Decision Notice
CHANGE TO A DEVELOPMENT APPROVAL
Planning Act 2016 Section 83

Development Approval: Material Change of Use – Impact – Dwelling House
Location: 1F Alderley Street, RANGEVILLE QLD 4350
Property Description: Lot 62 CC555
Relevant Planning Scheme: *Toowoomba Regional Planning Scheme 2012*

APPLICATION NUMBER:	MCUI/2019/3145/A
APPLICANT:	Excavation Equipment Pty Ltd
LOCATION:	1F Alderley Street, RANGEVILLE QLD 4350
PROPERTY DESCRIPTION:	Lot 62 CC555
APPROVED USE:	Dwelling House
ZONING:	Limited Development (Constrained Land) Zone

Approval: Material Change of Use for Dwelling
Location: 1F Alderley Street Rangeville
Property Description: Lot 62 CC555

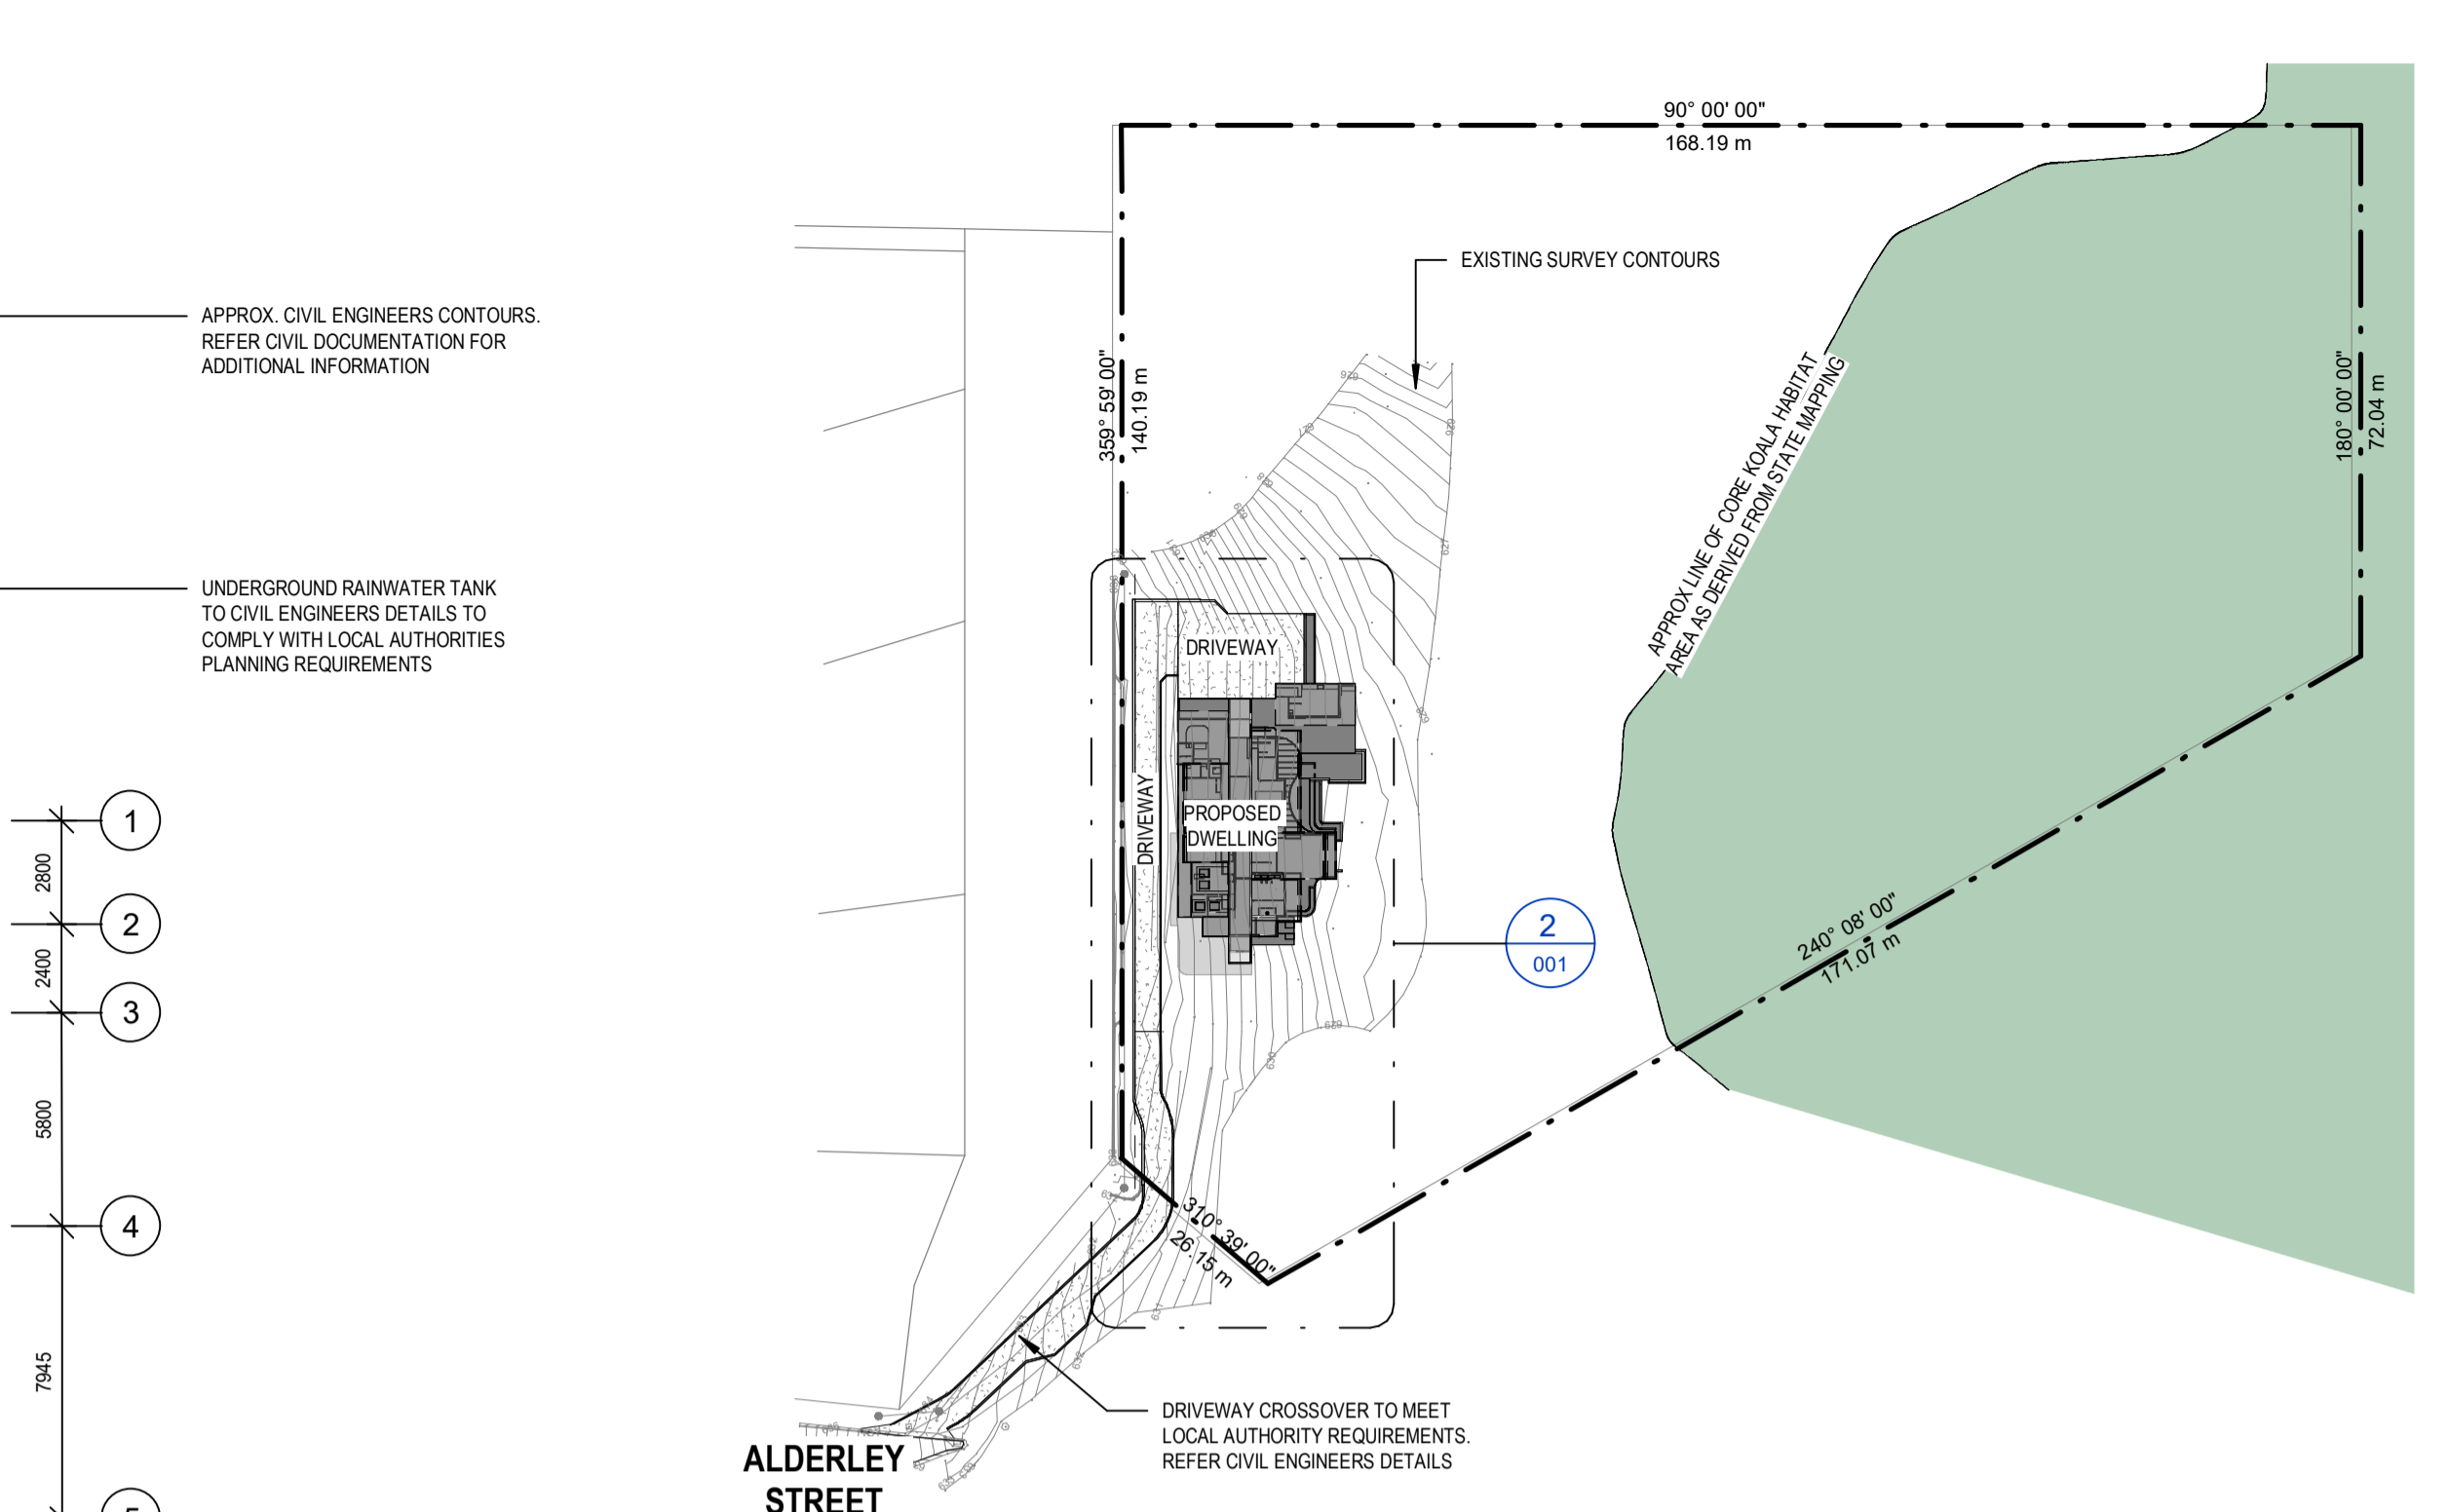
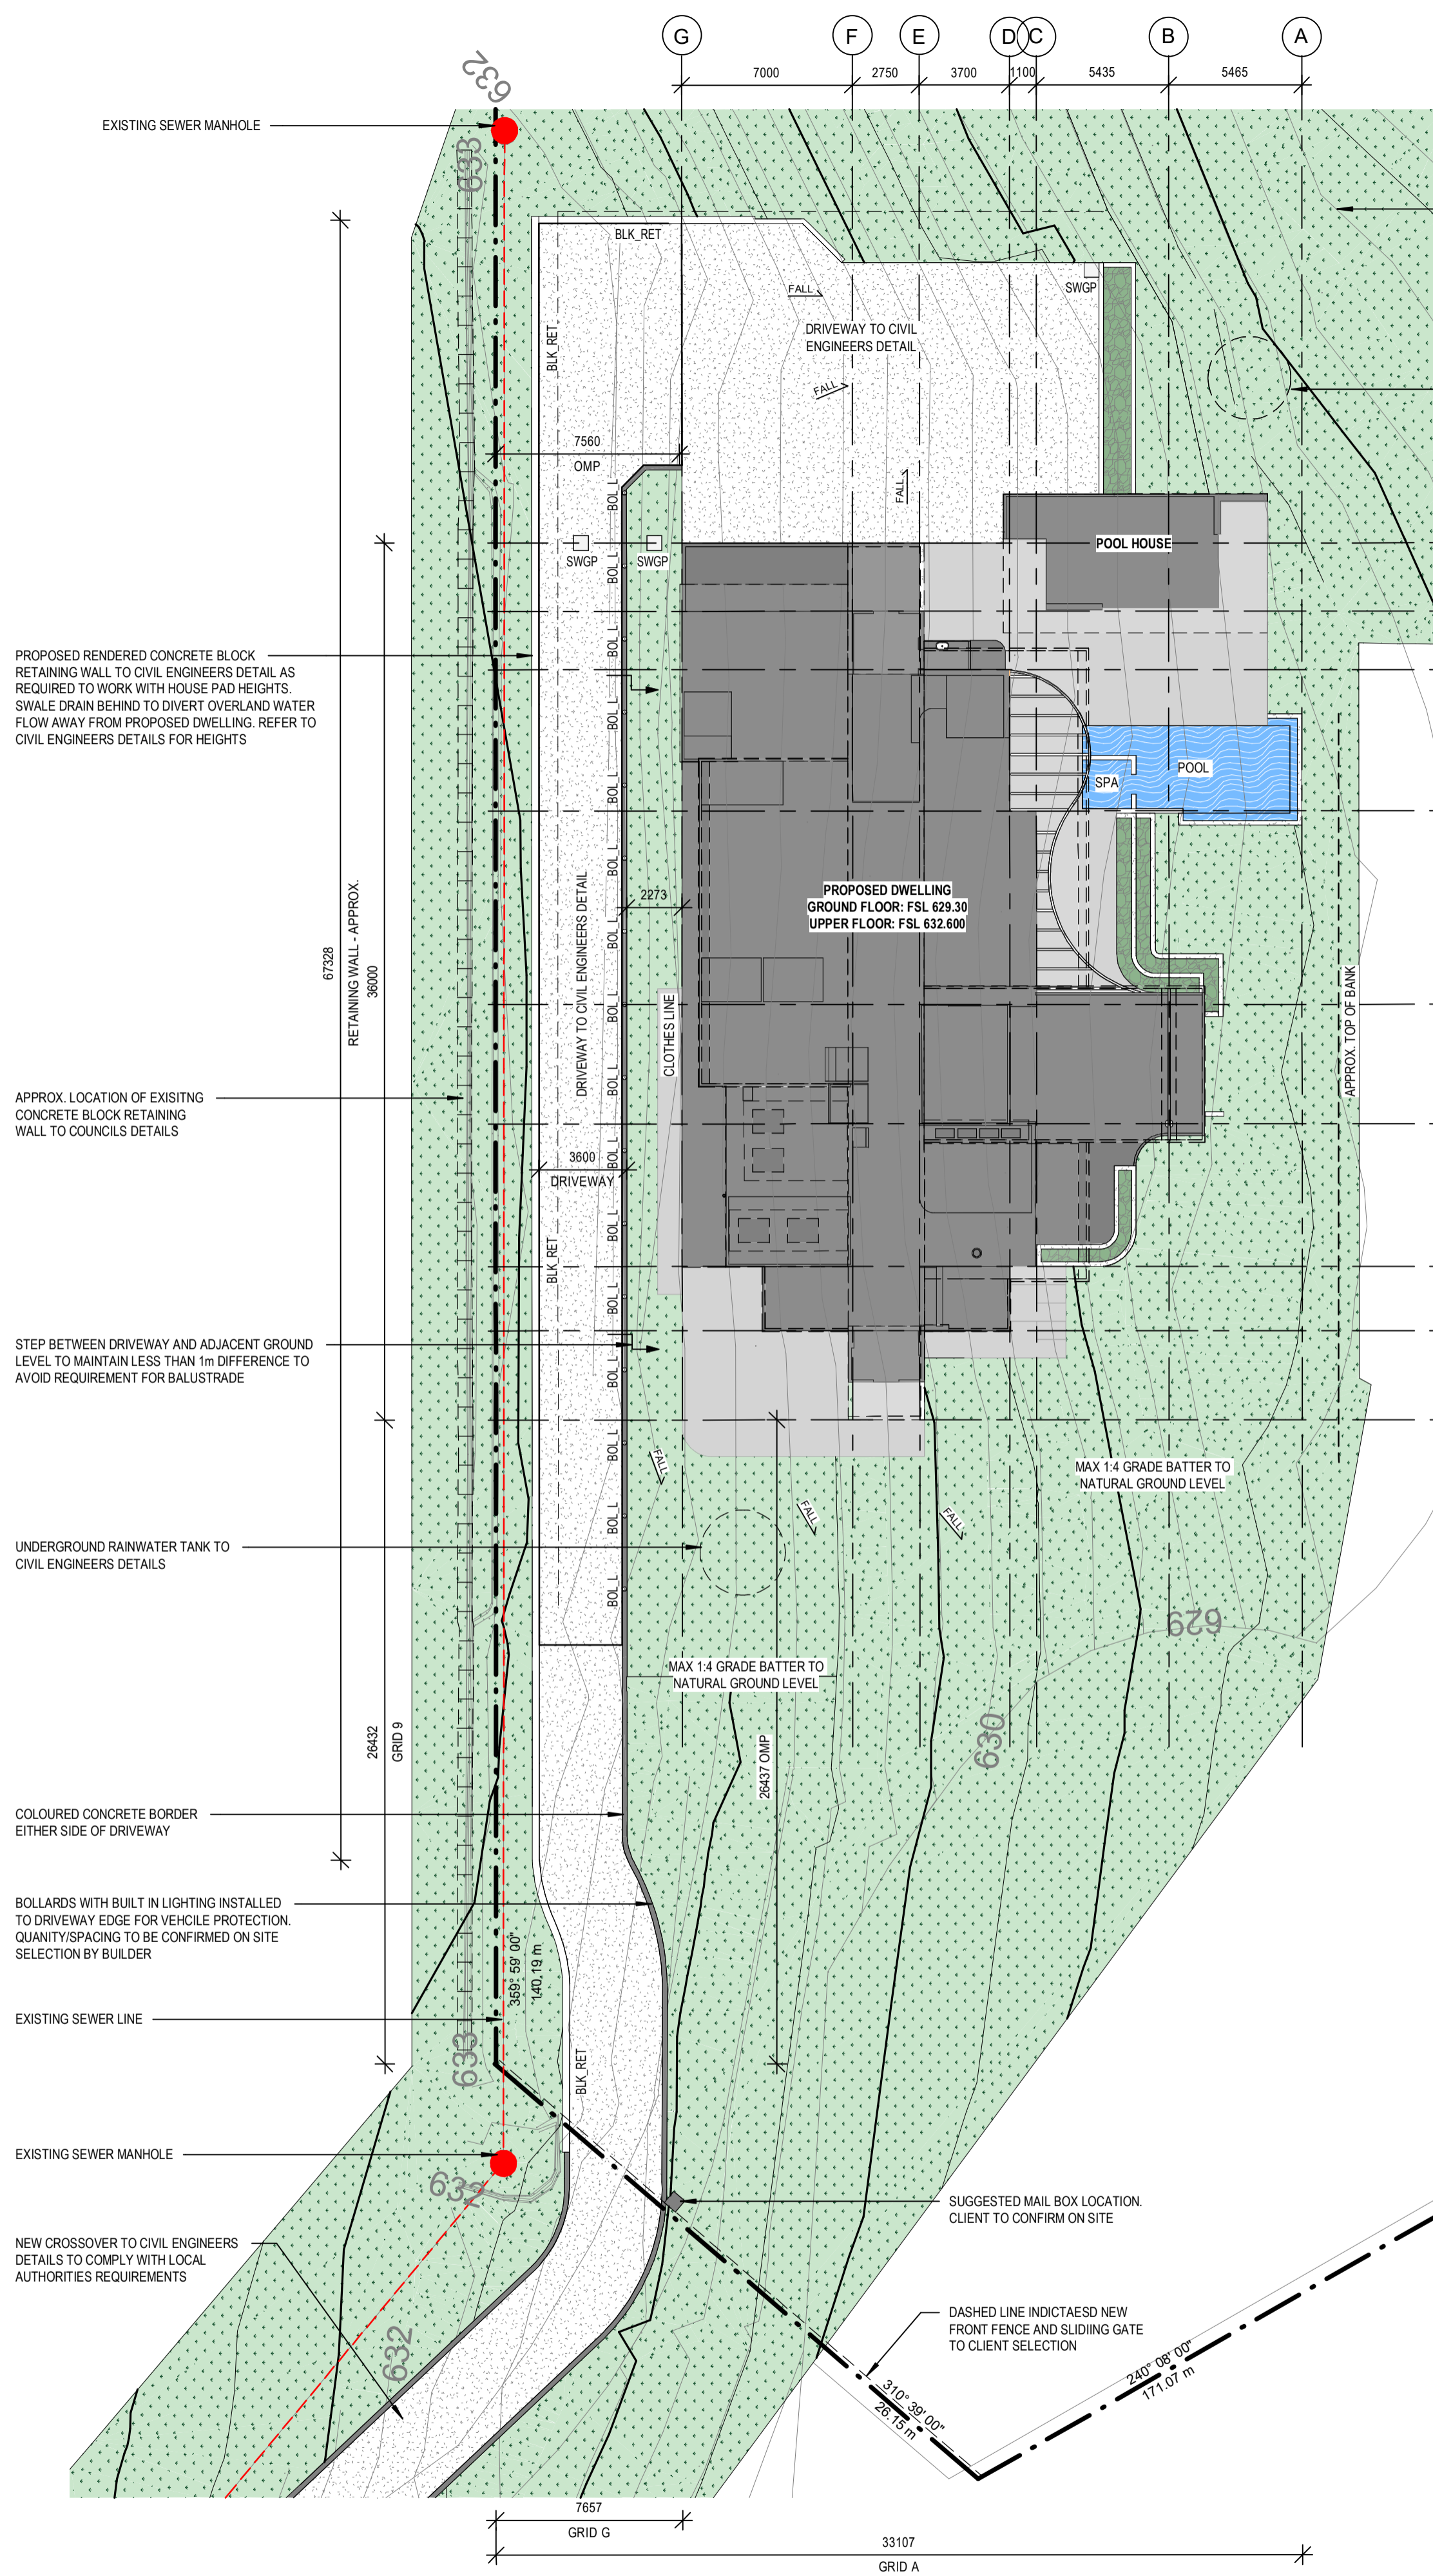
Plan No: 1319.24047, Issue 4
Description: Site Plan, prepared by VHD Studio and dated 17 December 2024
Amendments: Nil

FLOOR PLAN - GROUND
1 : 100

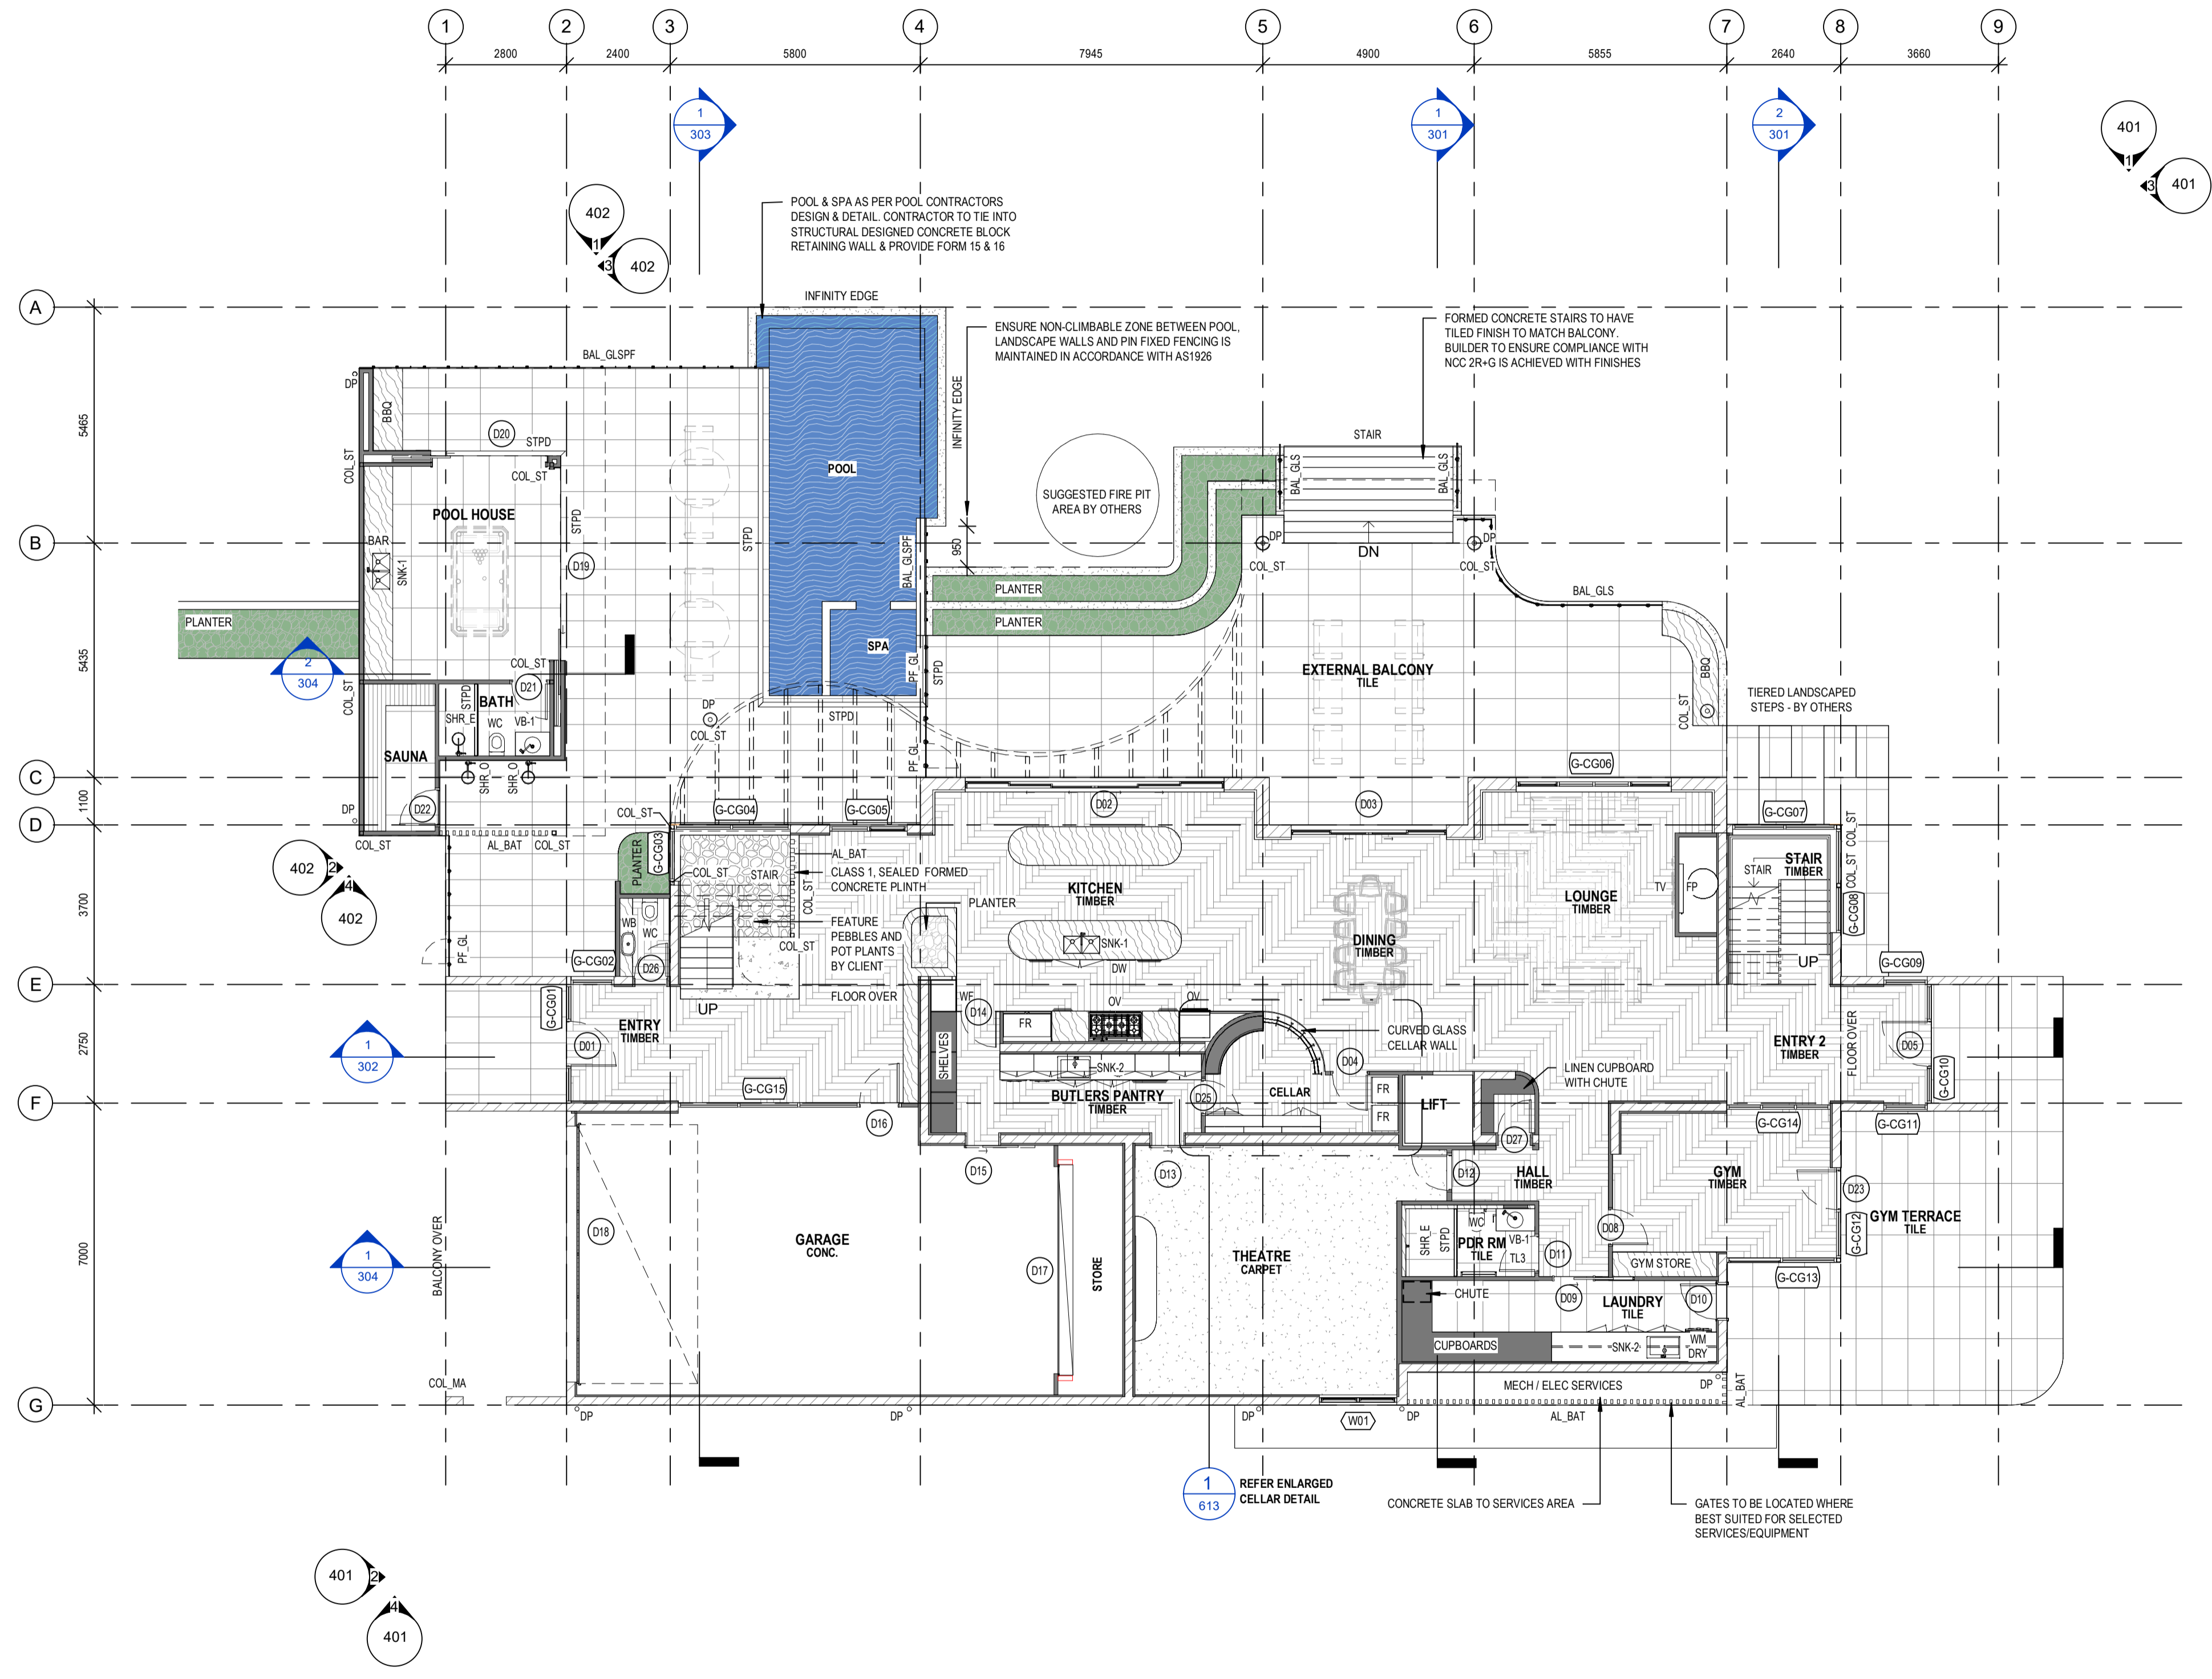
Plan No: 1319.24047, Issue 6
Description: Ground Floor Plan, prepared by VHD Studio and dated 17 December 2024
Amendments: Nil
